# UNITED STATES PATENT AND TRADEMARK OFFICE

APPLICATION NO.	FILING DATE	FIRST NAMED INVENTOR	ATTORNEY DOCKET NO.	CONFIRMATION NO.
10/590,463	08/23/2006	Mats Annerfeldt	2005P02667WOUS	9725
22116 7590 06/02/2009 SIEMENS CORPORATION INTELLECTUAL PROPERTY DEPARTMENT 170 WOOD AVENUE SOUTH ISELIN, NJ 08830				
EXAMINER				
WIEHE, NATHANIEL EDWARD				
ART UNIT		PAPER NUMBER		
3745				
MAIL DATE		DELIVERY MODE		
06/02/2009		PAPER

### Office Action Summary

Fig. 1'

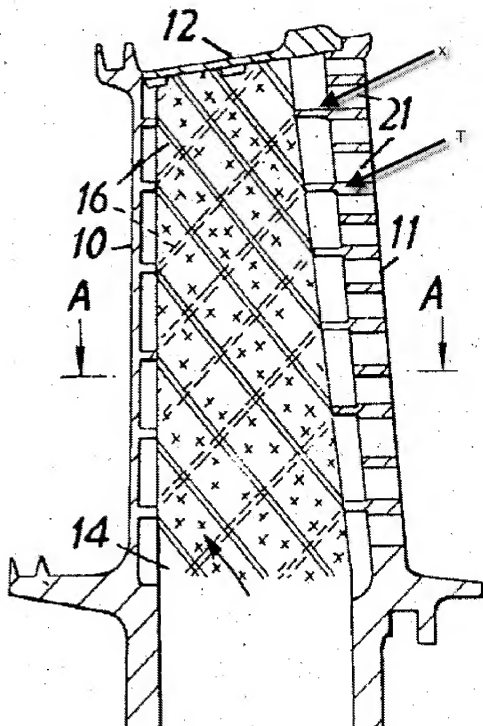
Claims 21-25 and 30-41, as far as they are definite, are rejected under 35 U.S.C. 102(b) as being anticipated by Moore (3,806,274). Moore discloses a blade for a gas turbine having an inner space is defined by a first, radially extending, pressure sidewall (17) and a second, radially extending, suction sidewall (18), an inlet area (13) arranged radially inward of the sidewalls, a top area opposite the inlet area (13) and at a radially outer end (12) of the first and second walls and an outlet area arranged toward the trailing edge (11) of the blade forming a passage for cooling fluid to flow from the inlet area to the outlet area. Moore includes a plurality of helical ribs (16) that extend from both the first wall (17) and the second wall (18) each substantially parallel along the respective walls and extending from the leading edge constituting the claimed plurality of first ribs and plurality of second ribs respectively. Further, the ribs (16) from each wall join at a singular point near the trailing edge that is coincident with the trailing edge passage ribs (X) that further include thickened portions (T) constituting reduced

flow area trailing edge outlet channels (21) (See Fig. 1' below). Since the trailing edge ribs (X) are formed at the juncture of the first and second sidewall ribs (16) they are construed as the portions of said first and second ribs in the "proximity of the trailing end". Also, these trailing edge ribs (X) form a common outlet channel for the first and second channels. The first side (17) ribs, in shadow in Fig. 1, extend along a first direction in proximity to the leading end that forms a first angle of inclination with respect to the rotary axis of the rotor. The second side (18) ribs, in solid lines in Fig. 1, extend along a third direction in proximity to the leading end forming a third angle of inclination with respect to the rotary axis of the rotor. The portions of the first and second ribs in proximity of the trailing end, i.e. those portions constituted by trailing edge ribs (X), extend in a second and fourth direction, respectively, that is inclined in relation to both the first and third directions, are equal to one another and are substantially parallel to the rotary axis. The first and third directions intersect each other and the third direction slopes from the leading end toward the rotary axis while the first direction slopes from the leading end away from the rotary axis. The ribs (16,X) extend over a leading zone and a trailing zone.
